The White Tanks Story and Related Articles

By: Julian J. Turner
Soil Conservation Service

WHITE TANKS
WATER

THE WHITE TANKS STORY

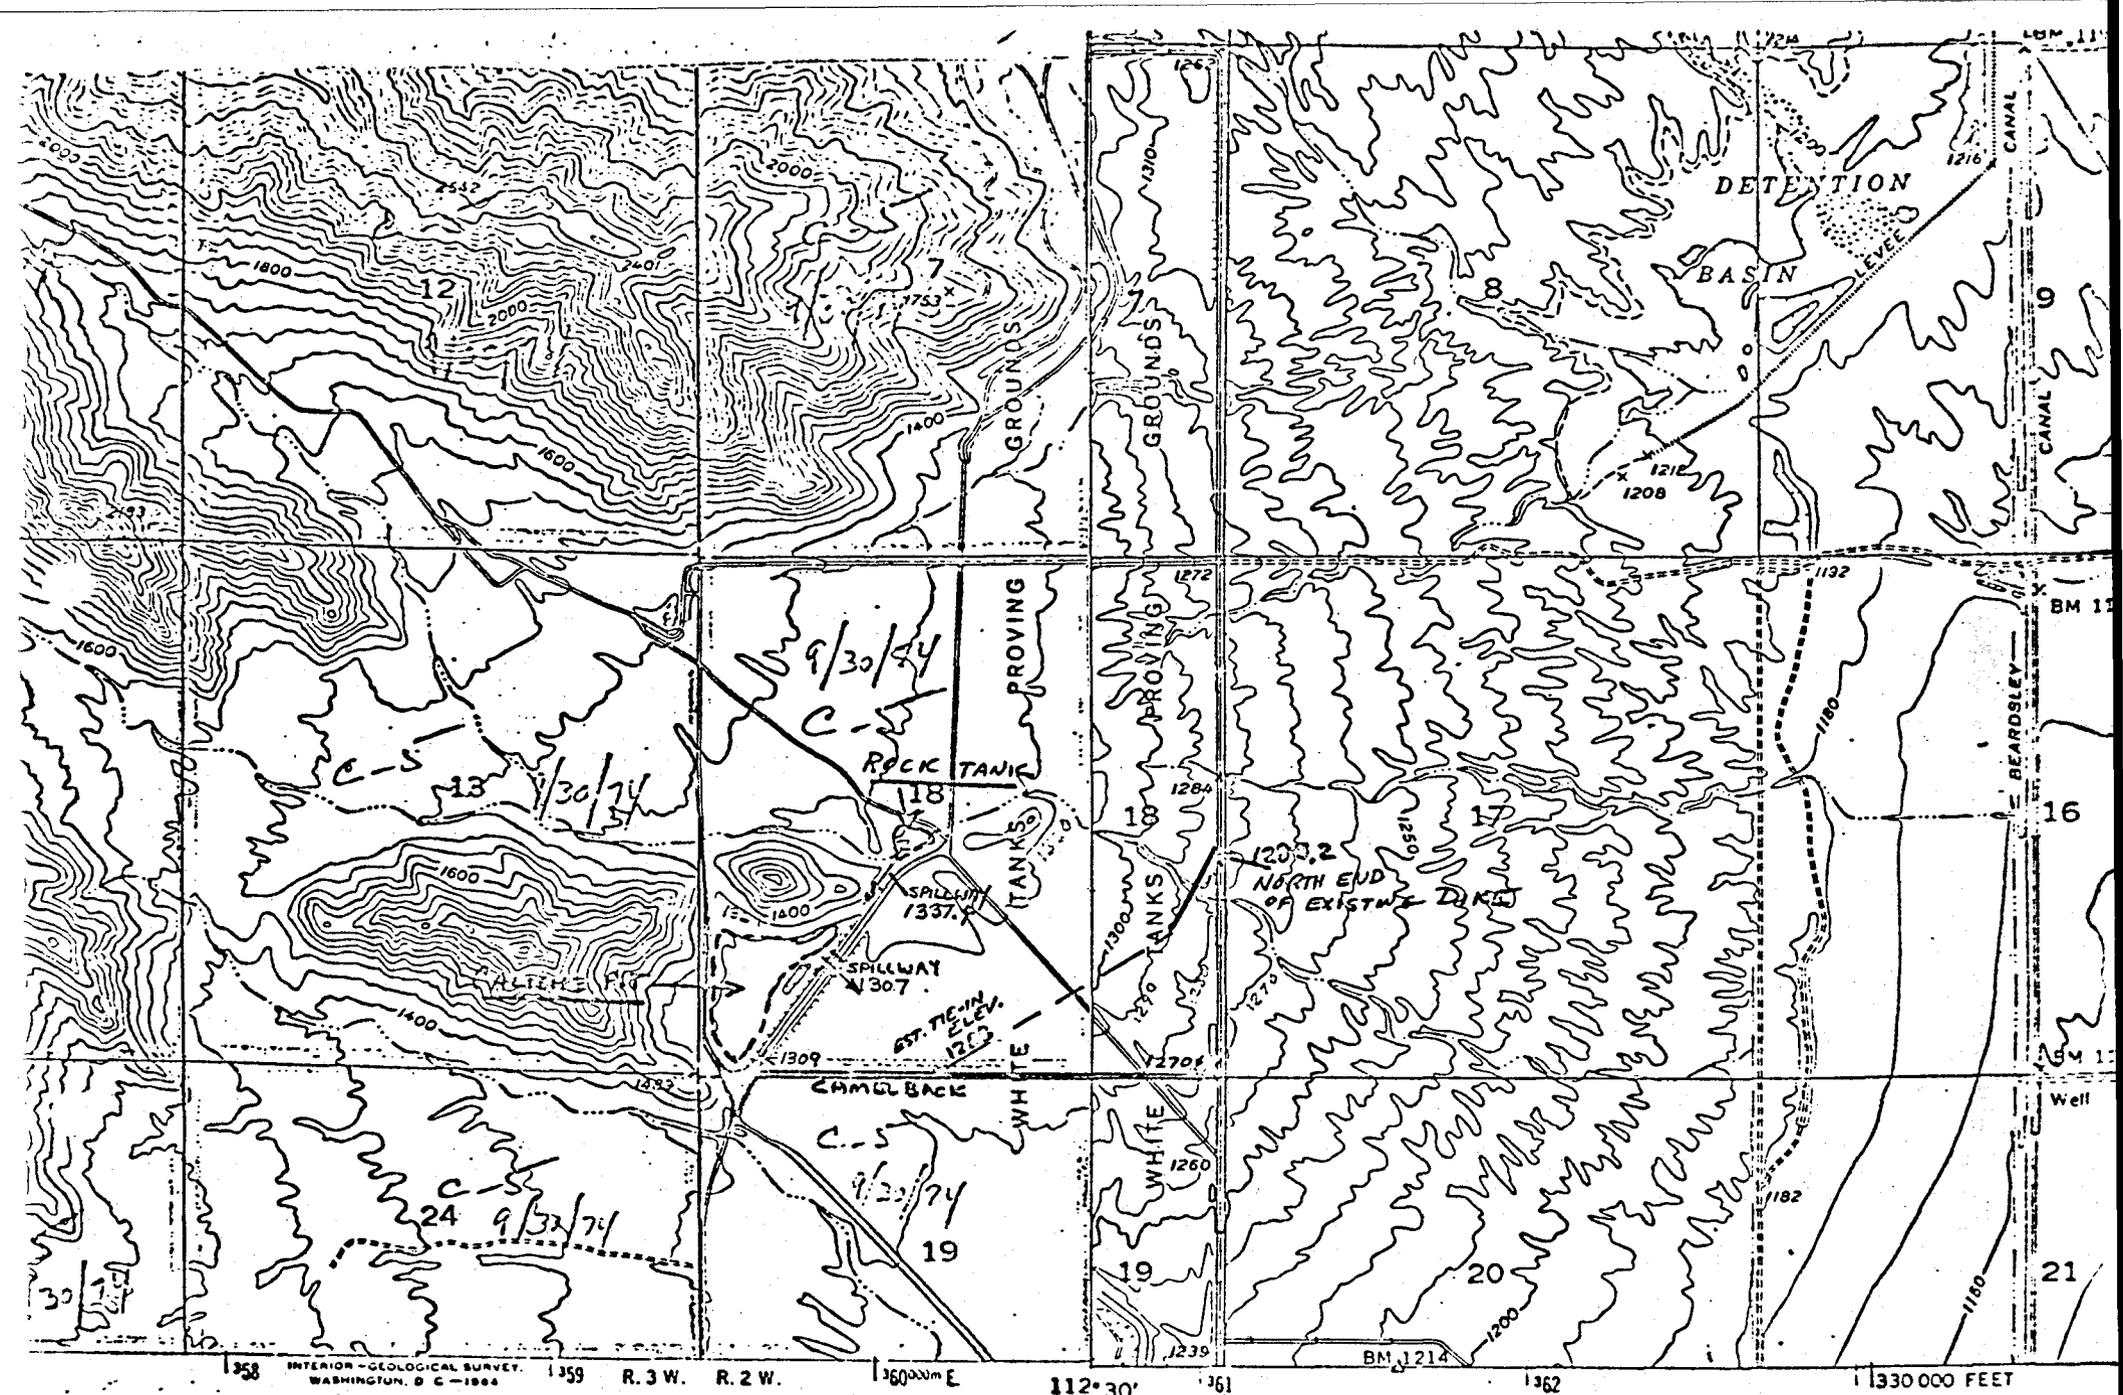
In our checking of the elevations we discovered Ray Hahn had assumed the water would flow out of the pit at the point marked 1309 on the map; it will actually leave the pit at the 1307 ft point. Thus his 460 acre-ft volume should be reduced by an estimated 50 acre-ft (25 acres x 2 ft). Thus the present pit volume is approximately 410 acre-ft; we could increase this by raising the present 1307 spillway level to 1309 ft but prefer to leave it as it is. We have a good well defined spillway area at present. If your office feels its needed, the dike extension would provide adequate diversion should the pit overflow.

REPORT OF FLOOD
 9-5-70
WHITE TANKS
EROSION CONTROL PROJECT
 U.S. DEPARTMENT OF AGRICULTURE
 SOIL CONSERVATION SERVICE
 PHOENIX, ARIZONA

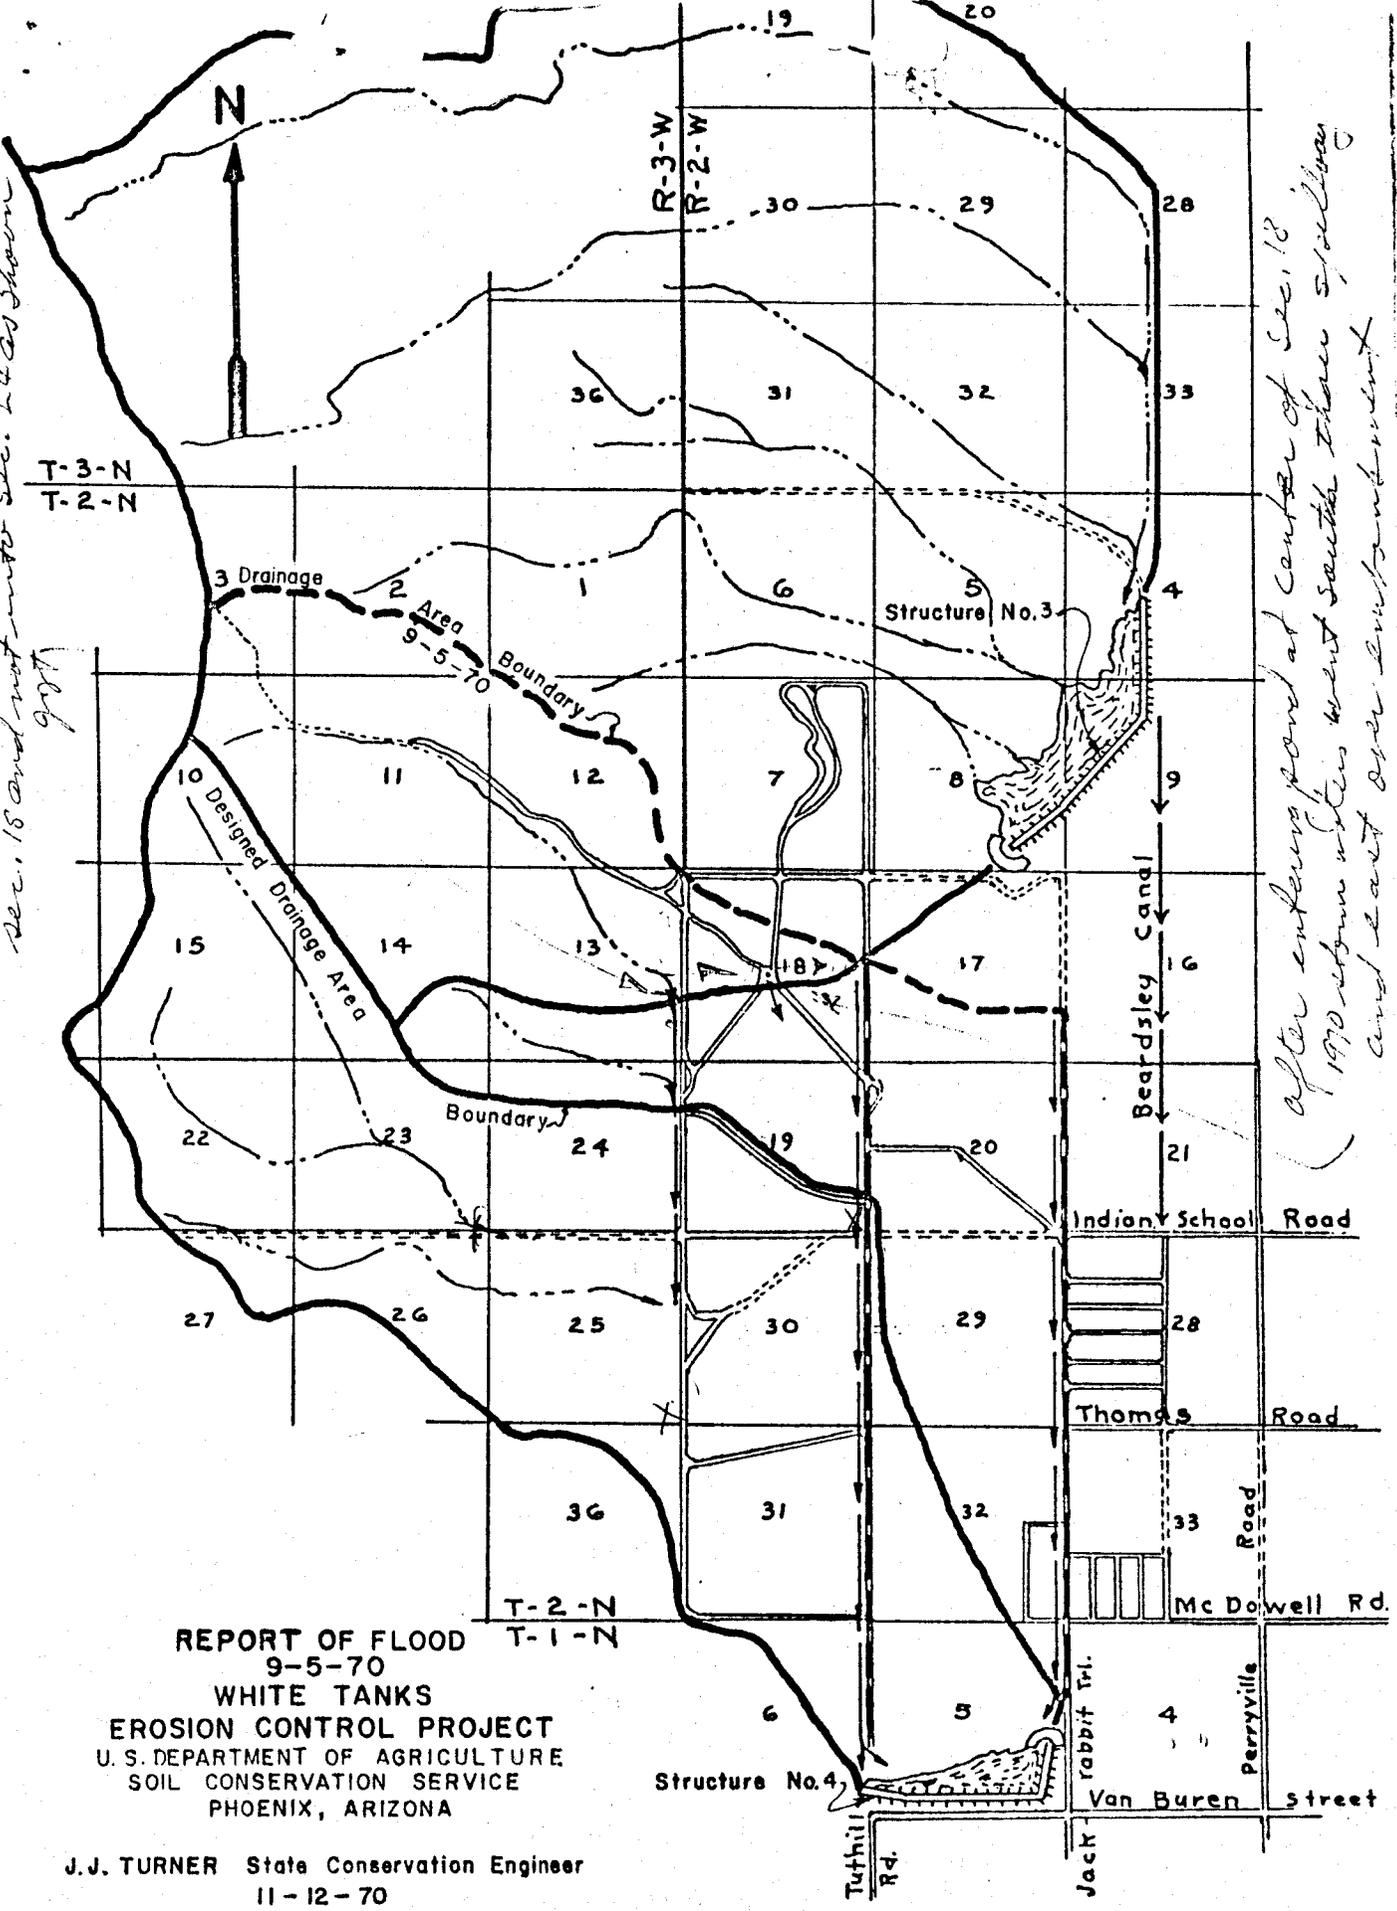
500 5, 170 D Storm went east into Sec. 18 and not into Sec. 24 as shown 9/27

(after entrance pond at center of Sec. 18 1970 storm water went south then S.W. and east over embankment)

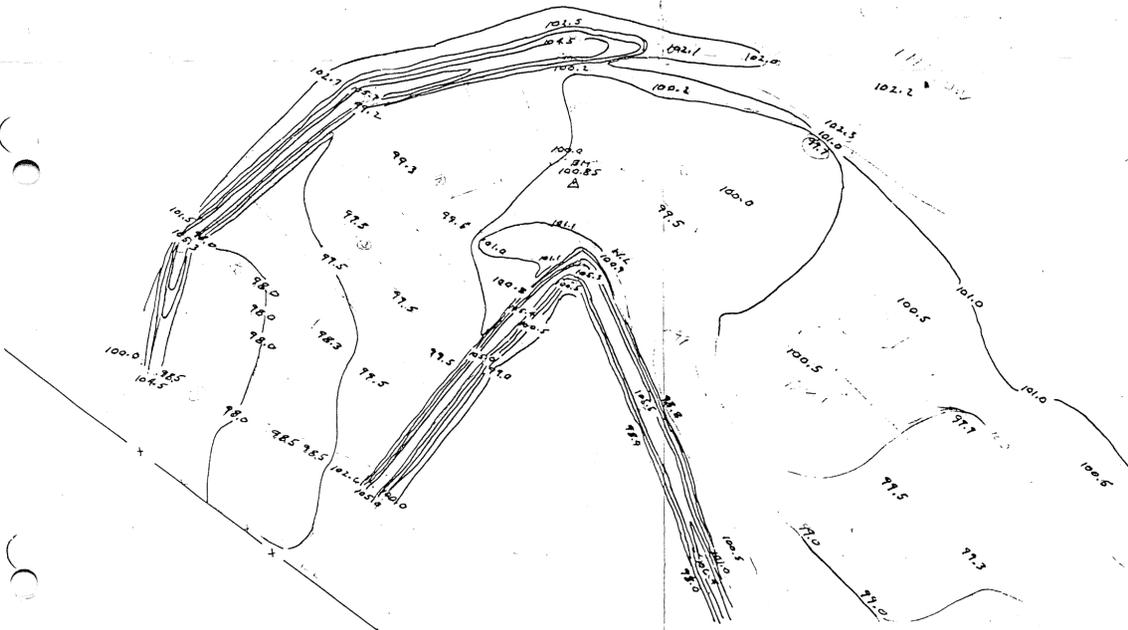
A. Redesign the roadway fills and channels in Sections 18 and 13 so as to permit the four square mile area in parts of Sections 2, 3, 10, 11, 12, 13 and 14 so the area will drain into Structure No. 3 as originally planned.

See map attached.
